Re: **RE: Supplemental Information for the November 16th Planning Commission Meeting  
Response To Questions and Comments from Commissioners  
at the November 16, 2023, Planning Commission Meeting  
and  
Request for Distribution of  
attached 3462 Lilac Trail,  
Supplemental Civil Engineer Letter, dated November 22, 2023.**

November 22, 2023  
Work Order No. 19.33

**RE: Wall Sub-Drainage System  
Proposed Single Family Residence, Attached Garage & ADU  
3462 Lilac Trail, Calabasas, CA 91302**

PLATE RD-2

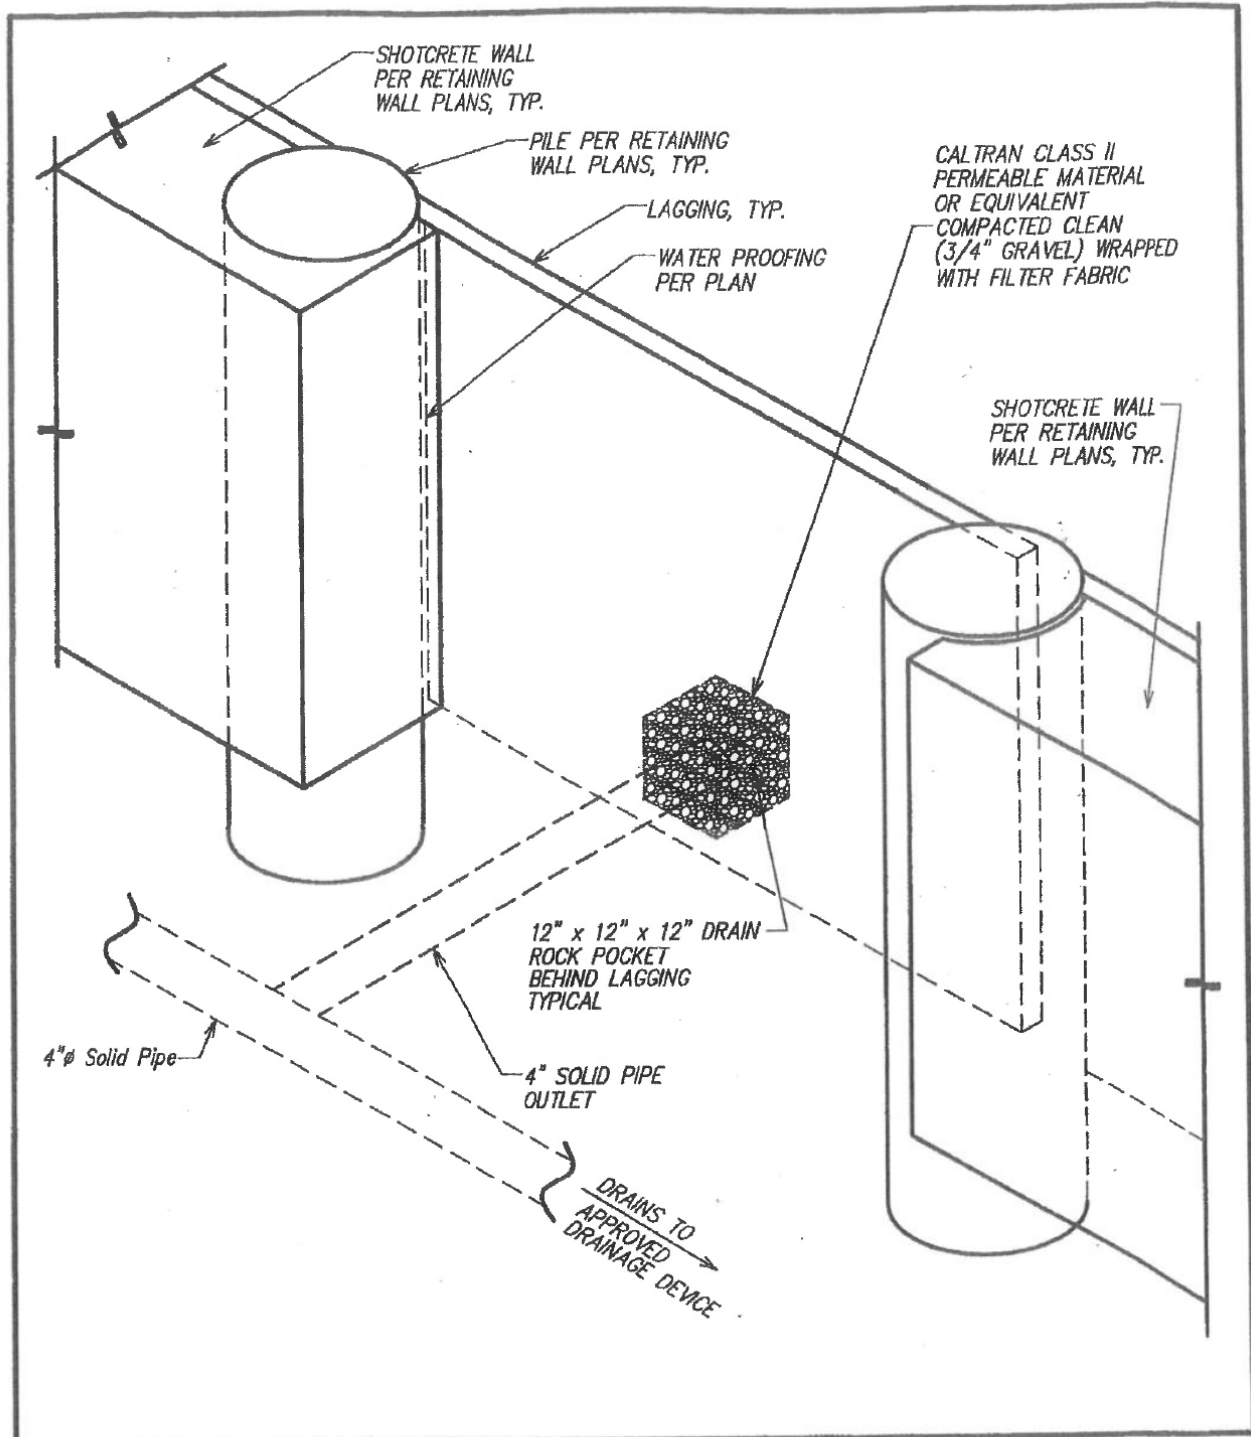
The intent of this document is to assist in clarifying a planning commissioner's question regarding retaining wall subdrainage / hydrostatic relief from the proposed structures at the subject site.

In addition to details "Plate RD-2", "Plate SD-1 and SD-2" (see attached hereto), the report has also included a potentially high ground water table (of 50-feet below grade) into their slope stability analysis.

In addition to the above noted Soils Engineer of Record recommendations, the Soils Engineer also cites the requirements for standard / regular waterproofing at the back of all subterranean portions of retaining walls. The requirement for waterproofing is also supported by both myself the Civil Engineer of Record and cited on the architectural plans as well.

On the basis of the above, the Site nor the design appears to require any special (non-regular) retaining wall waterproofing, back-drain, sub-drain, French-drain and/or other hydrostatic relief system. It is not a typical standard of industry to include specific waterproofing details on entitlement level plans for approval, however it is standard of industry to include them with construction level plans and specifications, which will be required at the building permitting approval stage of the development.
